Addendum 02

Date: 05-21-2026
Project: 22011 – Spin Lofts
 521 21st Ave
 Council Bluffs, IA

Spin Lofts
TD2#: 748-886
Addendum 2
05/15/2026

G1 FLOOR PLAN - LEVEL 03
A1.2 SCALE: 1/8" = 1'-0"

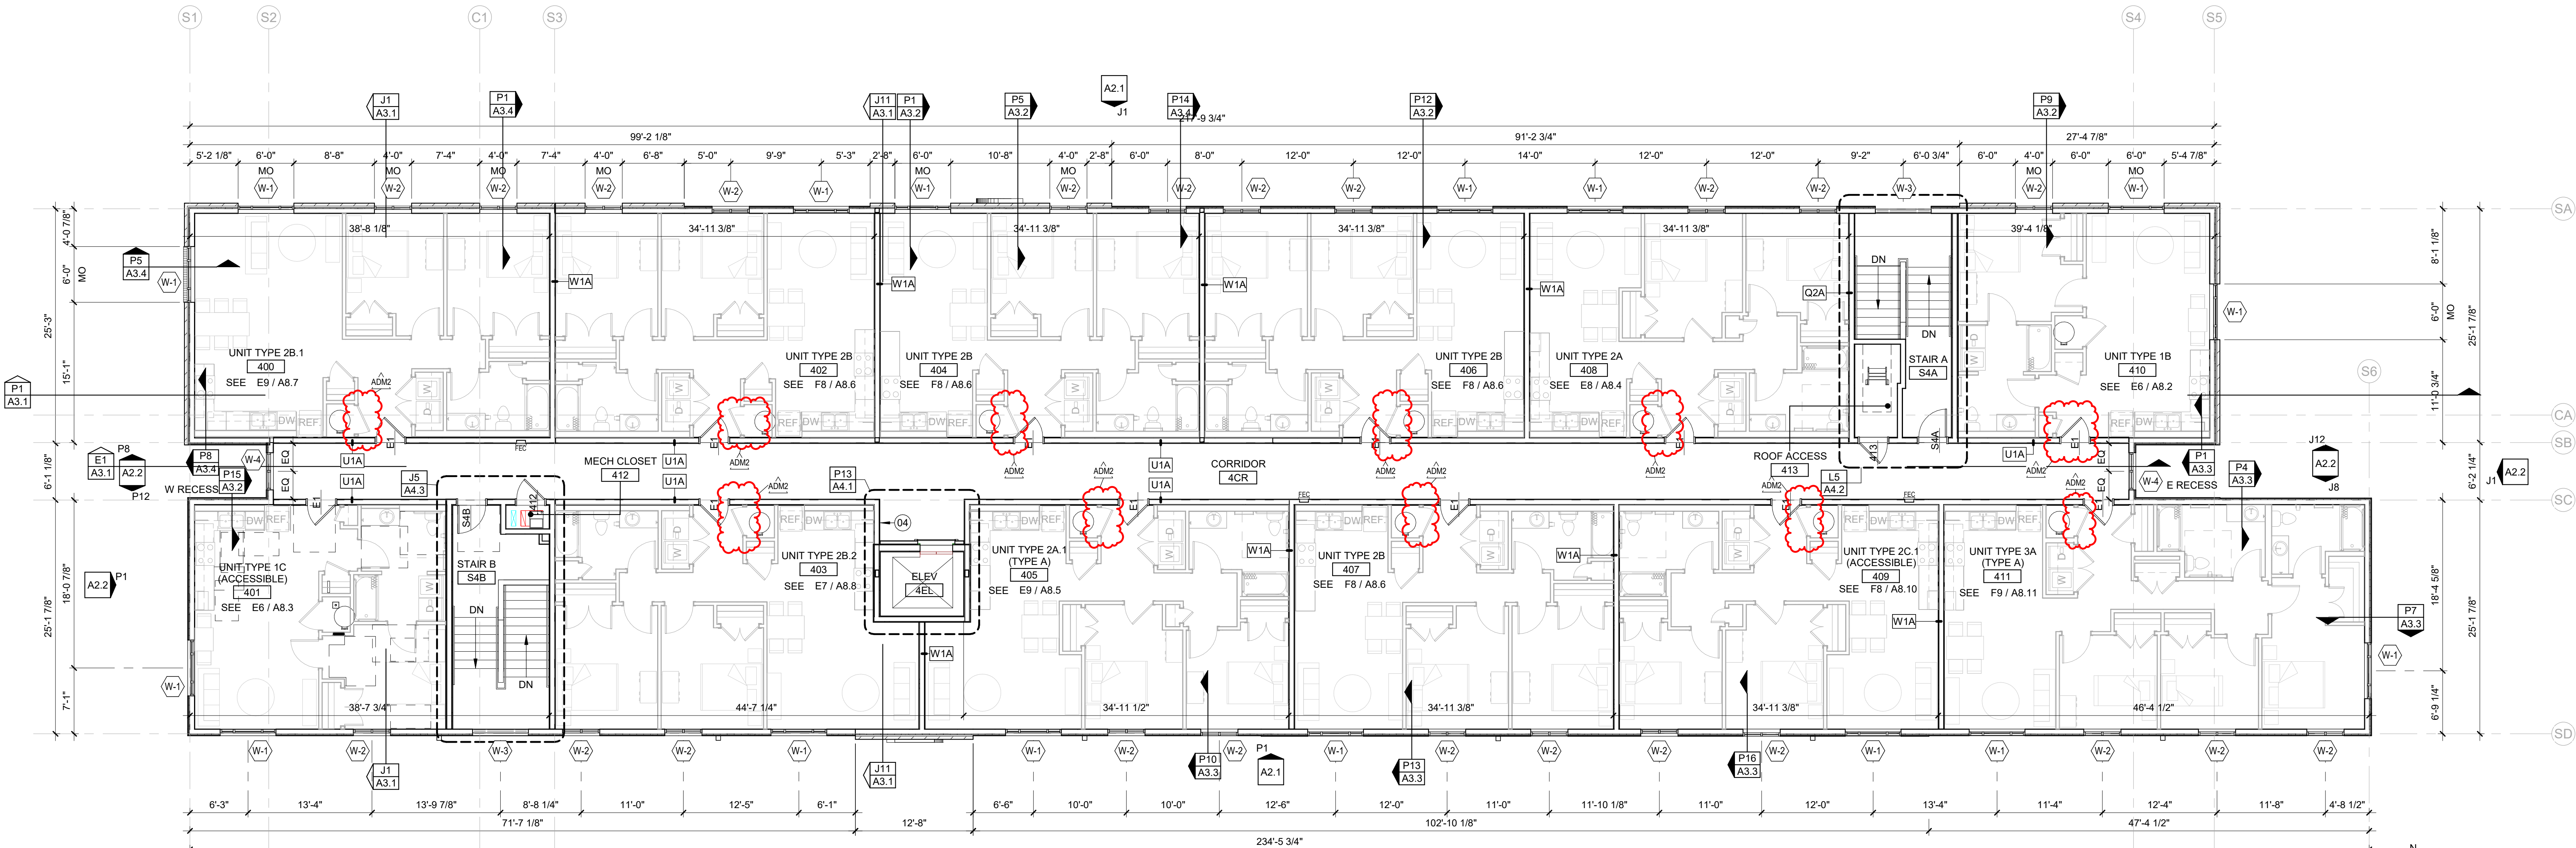
- a. Revise door swing at unit mechanical closets where noted on the floor plans.
6. Sheet A3.2: WALL SECTIONS
 - a. Add notes regarding vapor barrier at exterior walls, especially at roof and floor truss locations.

G4 TYP. PARAPET DETAIL AT BRICK WALL
A5.1 SCALE: 1 1/2" = 1'-0"

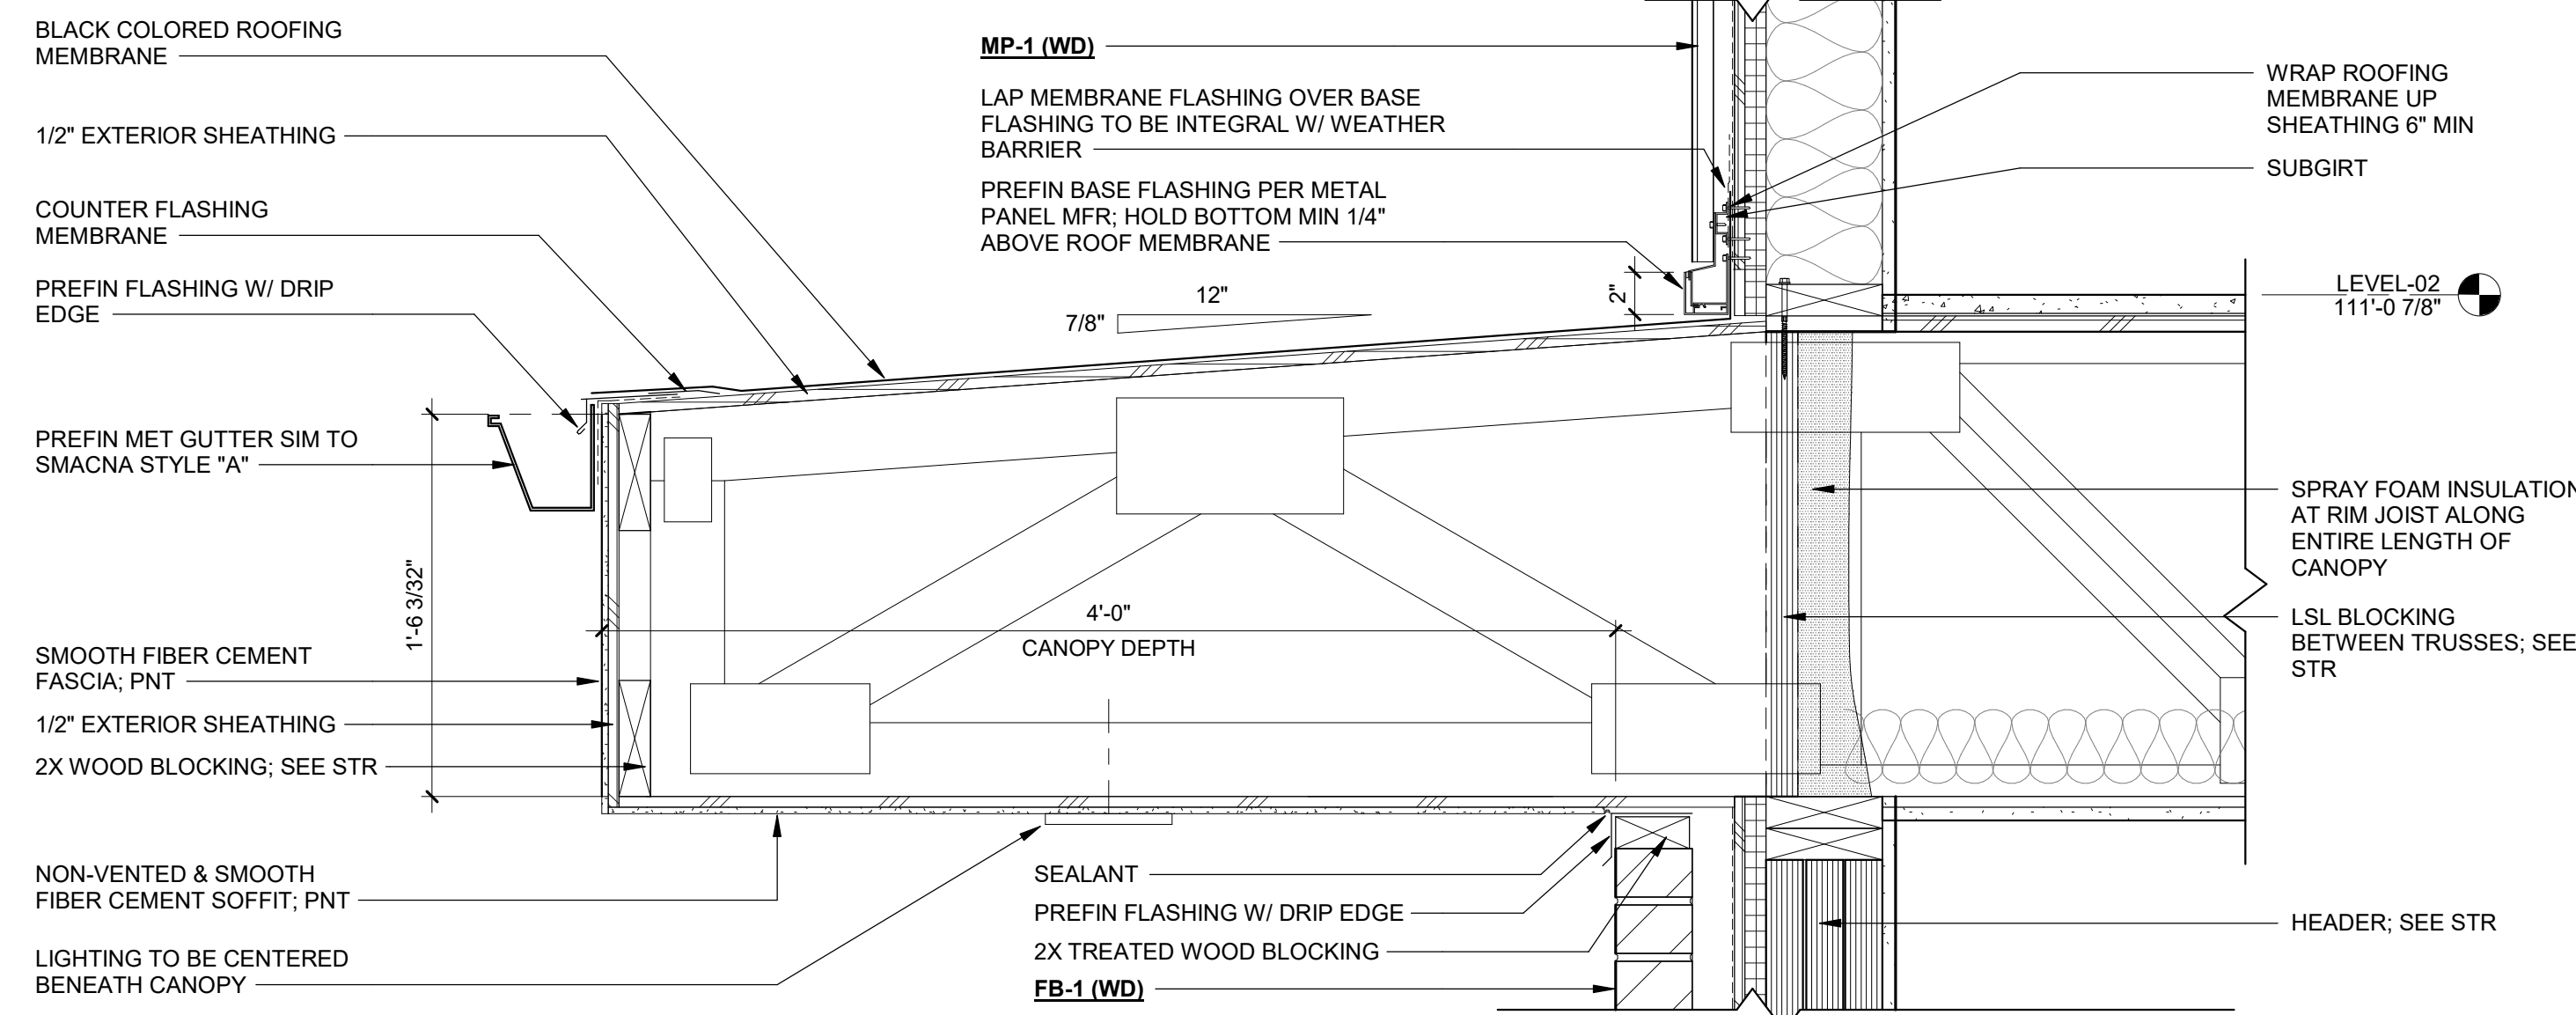
7. Sheet A5.1: BUILDING DETAILS
 - a. Add notes to details G4, D14, G14, and K14, regarding continuation of vapor barrier.
8. Sheet A5.2: BUILDING DETAILS

E4 TYP. S FACADE PARAPET DETAIL AT LAP SIDING
A5.2 SCALE: 1 1/2" = 1'-0"

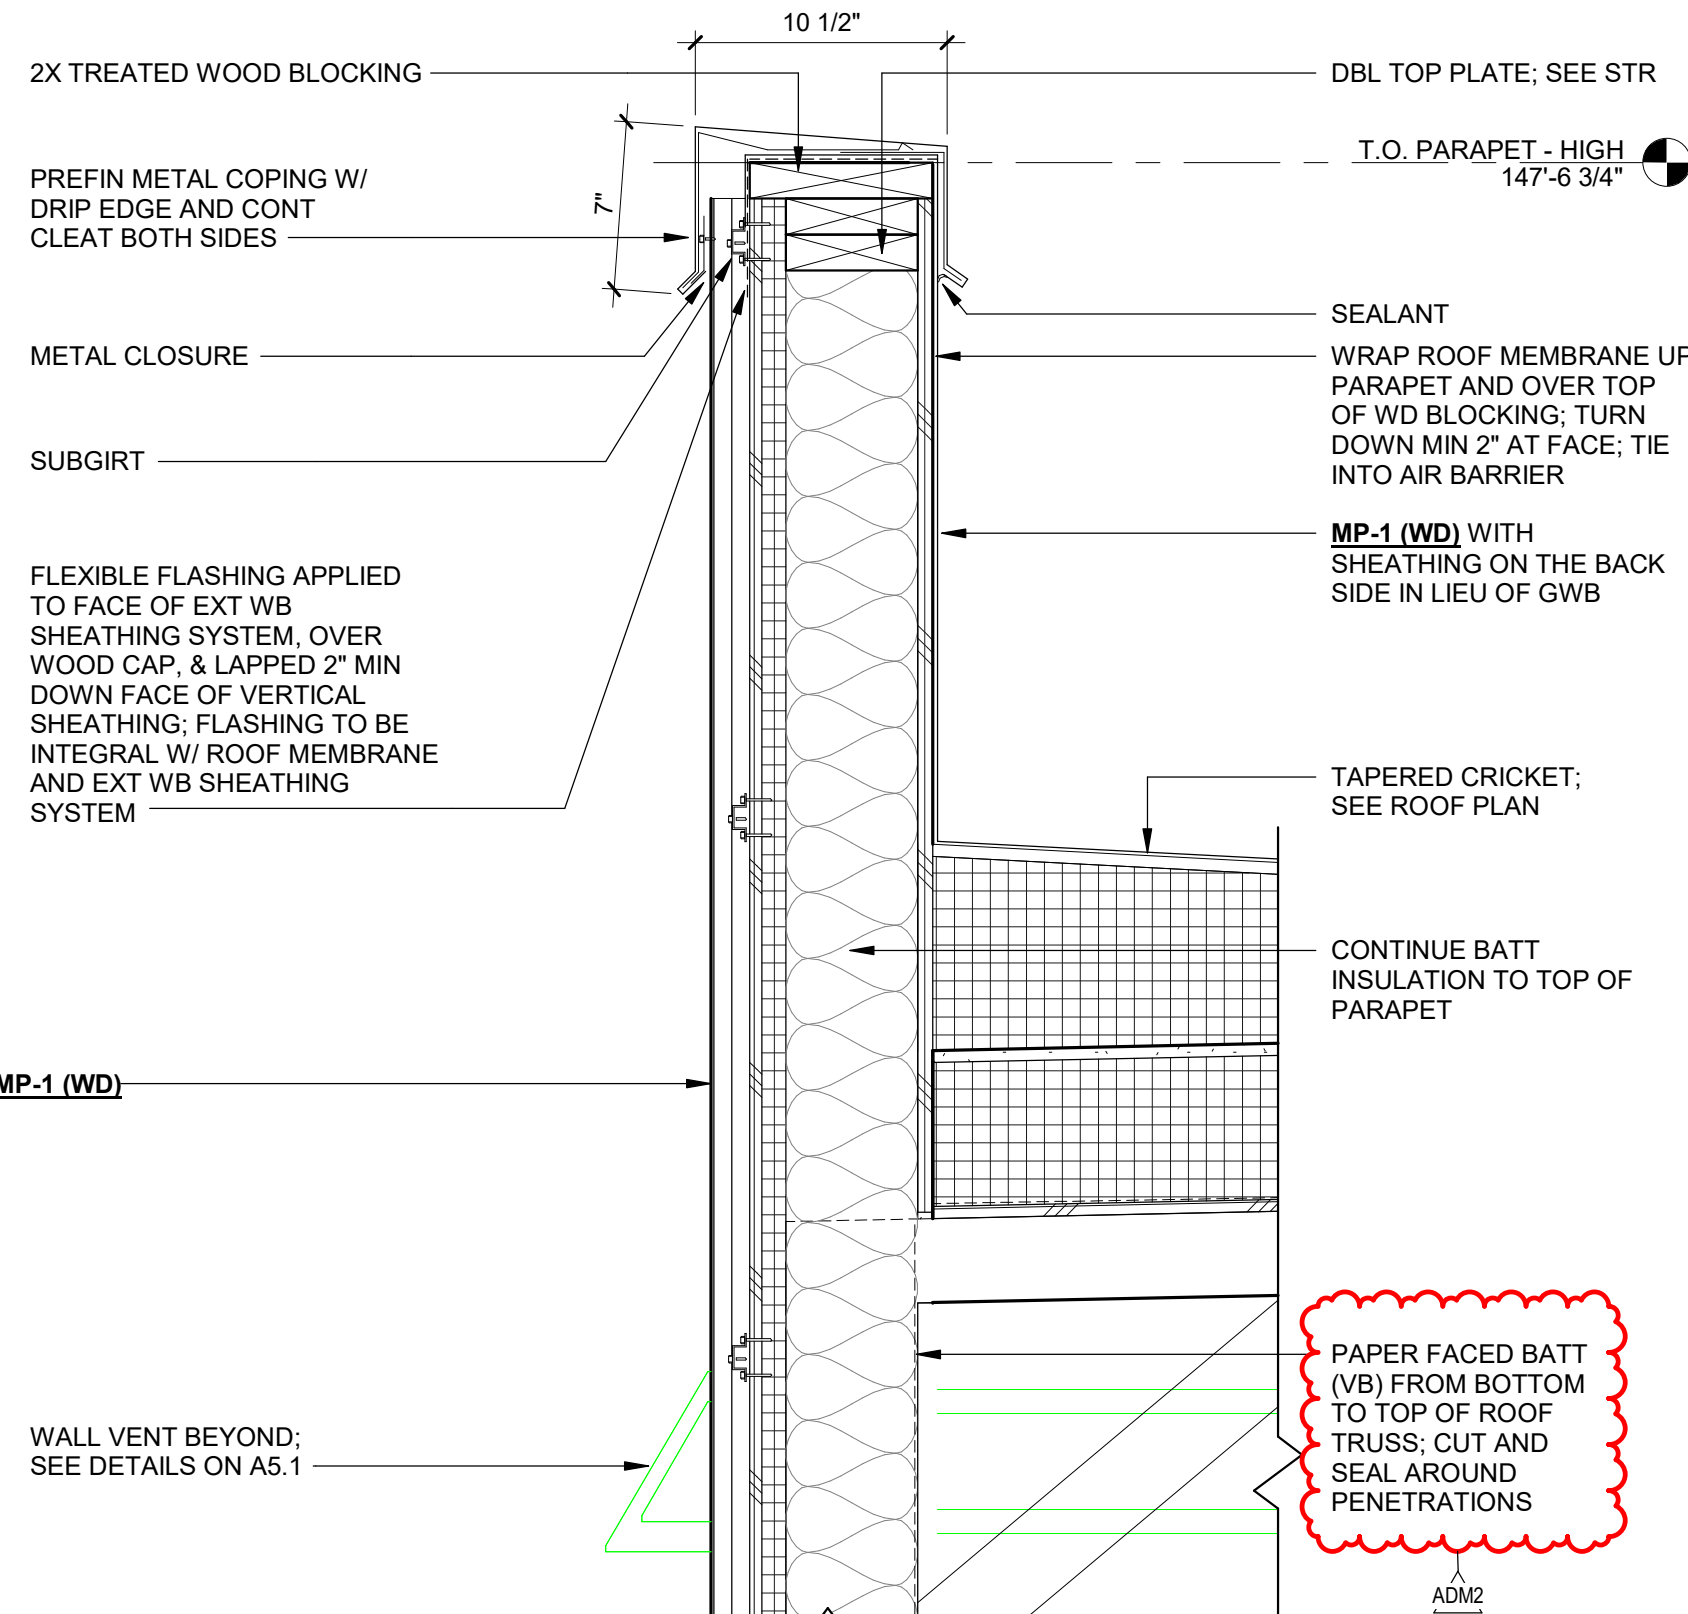
- a. Add notes to details E4, E9, E14, K9, and K14, regarding continuation of vapor barrier.
9. Sheet A5.3: BUILDING DETAILS
 - a. Add notes to details E14, regarding continuation of vapor barrier.

D5 PLAN DETAIL - OUTSIDE CORNER, LAP SIDING TO METAL PANEL
A5.4 SCALE: 1 1/2" = 1'-0"

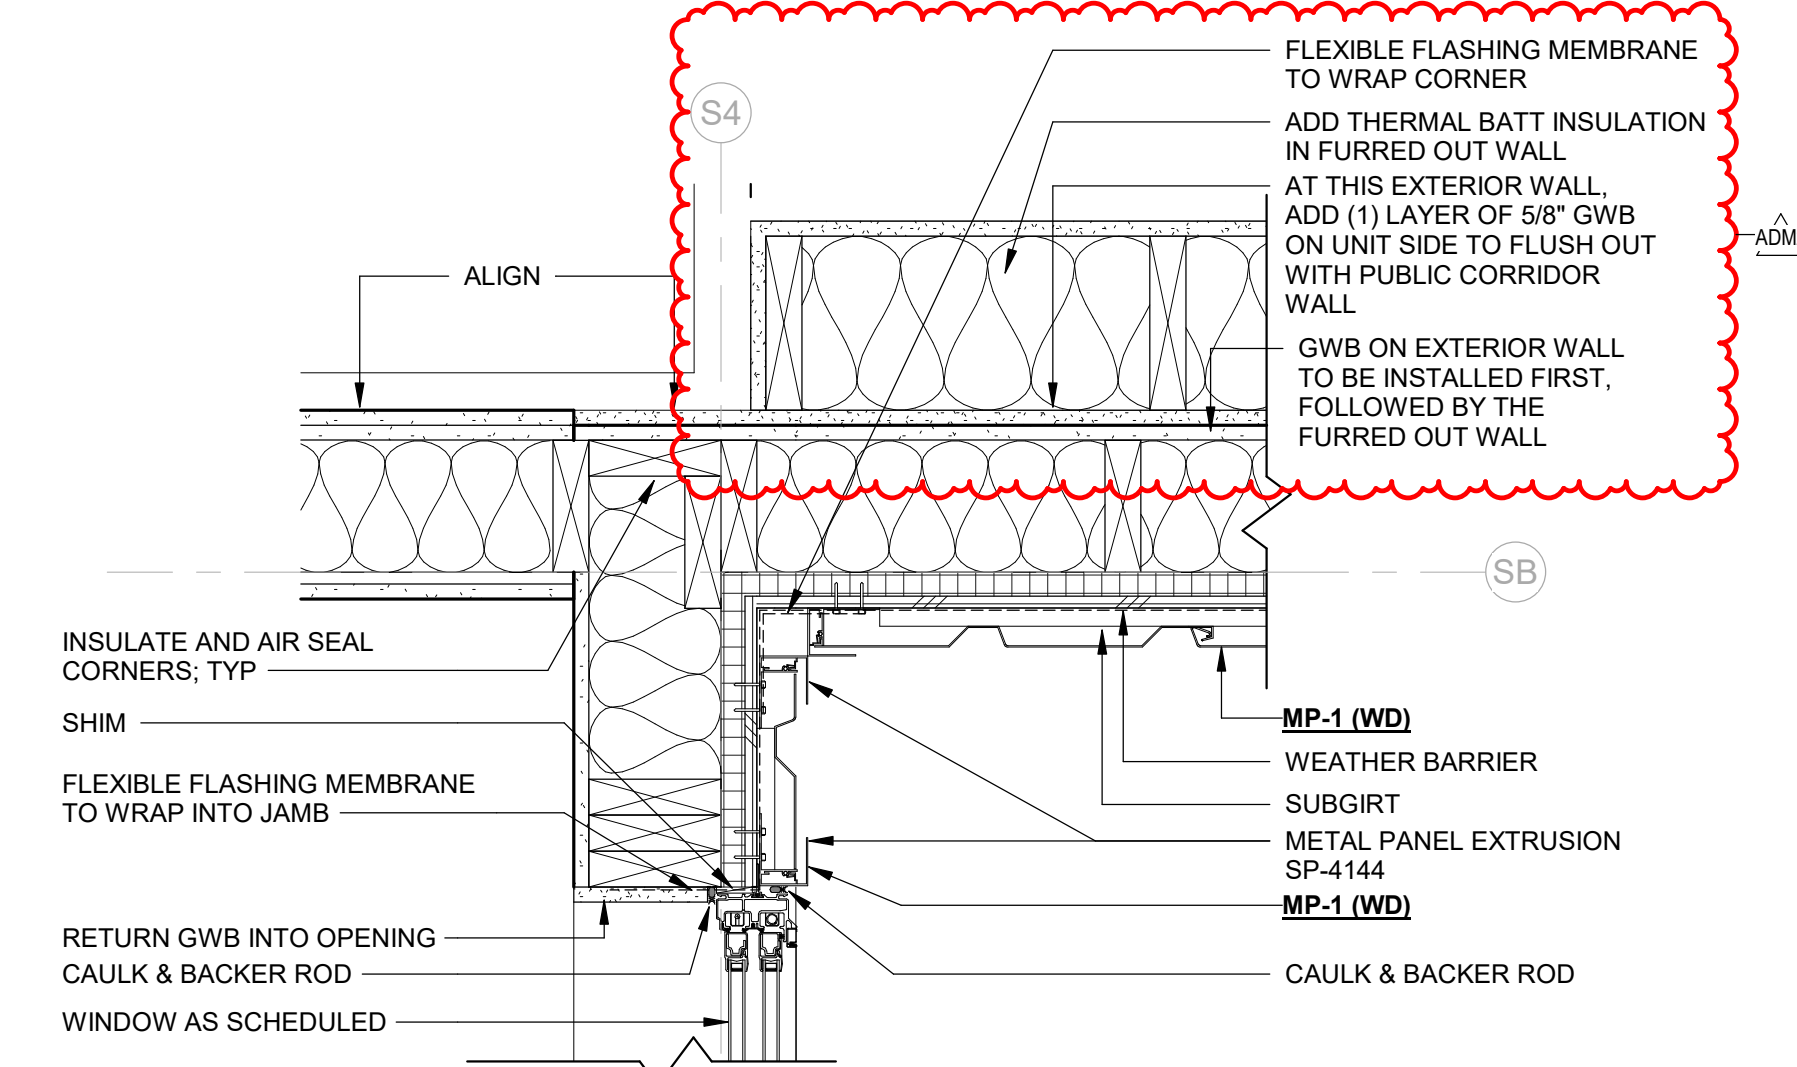
10. Sheet A5.4: BUILDING DETAILS
 - a. Add notes to details D5, G5, and D15.
11. Sheet A8.4: ENLARGED PLANS & ELEVATIONS – UNIT 2A
 - a. Revise door swing at unit mechanical closet.
